## Planning Officer's Report – LDCA MAY 2021

<b>APPLICATION</b>	<b>2021/09</b> – Proposed Covered Area and Installation Photovoltaic Panel System to Mantis Hotel
<b>PERMISSION SOUGHT</b>	Permission in <b>Full</b>
<b>REGISTERED</b>	16 <sup>th</sup> February 2021
<b>APPLICANT</b>	St Helena Hotel Development Limited
<b>PARCEL</b>	JT050045 & JT050012
<b>SIZE</b>	0.34 acres (1402m <sup>2</sup> )
<b>LAND OWNER</b>	Private
<b>LOCALITY</b>	The Mantis Hotel, Main Street, Jamestown
<b>ZONE</b>	Intermediate Zone
<b>CONSERVATION AREA</b>	Jamestown Conservation Area
<b>CURRENT USE</b>	Hotel
<b>PUBLICITY</b>	The application was advertised as follows: <ul style="list-style-type: none"><li>▪ Independent Newspaper on 19<sup>th</sup> February 2020</li><li>▪ A site notice displayed in accordance with Regulations.</li></ul>
<b>EXPIRY</b>	5 <sup>th</sup> March 2021
<b>REPRESENTATIONS</b>	None Received
<b>DECISION ROUTE</b>	<del>Delegated</del> / <b>LDCA</b> / <del>EXCO</del>

#### **Diagram 7: Proposed North Elevation**

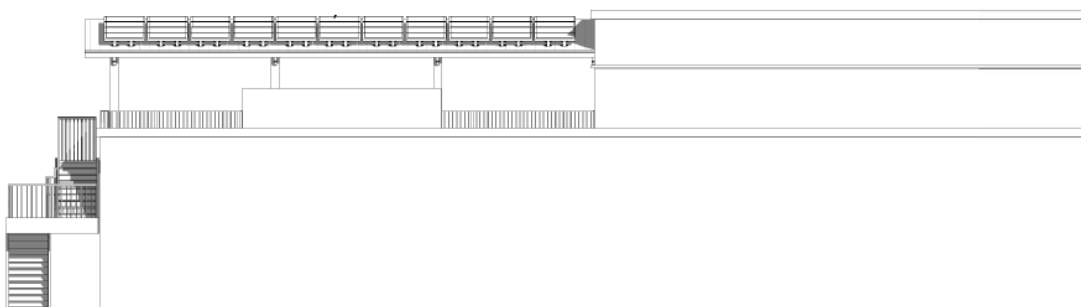
The issue for consideration is the erection of a wooden structure (Pergola) that will cover over the area that has been provided to retain openness of this area. It is the erection of this structure that is an issues to consider. The installation of the photovoltaic solar panel system over the new roof area is more incidental, although it does raise number of issues of its aesthetics and whether it in cognisance with the historic setting of this building at the level of the installation when there may other better alternative location.

It is considered that retaining the open terrace, as it has been designed, should be a major consideration. The issues raised by the applicant that there are management

issues and the area is a heat trap appears very weak. Most open terraces will have table with umbrellas that open out to provide protection from the sun and at certain times of the day, the open element is there to be enjoyed. Covering over this area and creating close feel and visual built form needs to be resisted and it is considered to compromise design objectives for this development.

**Diagram 7: Proposed Supports for the Pergola**

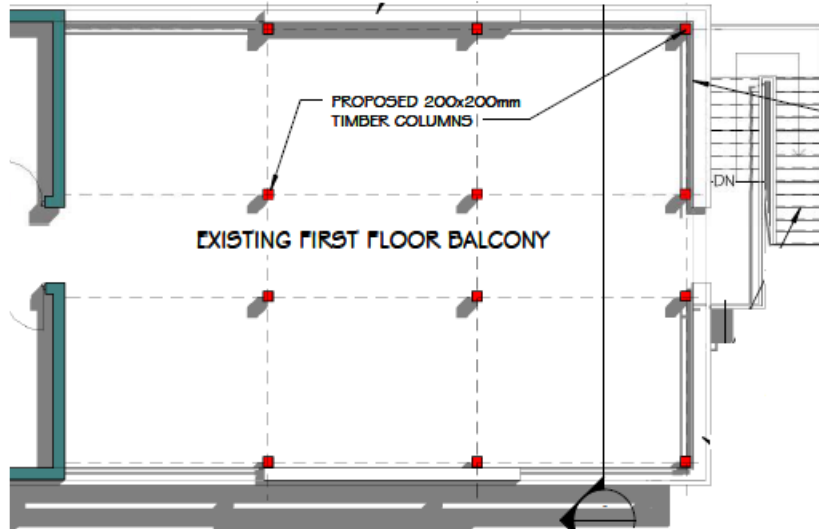
Following the assessment of the proposal, the applicant was advised of the issues and potential adverse impact arising from the development and requested to reconsider the proposed development. The applicant was also advised of the Planning Officer's in respect of the proposal. In response to the applicant provide its justification for the proposed development and the various options that were considered. The whole background to the proposed development is install PV panel to reduce the building's carbon footprint and hence reduce the energy costs.
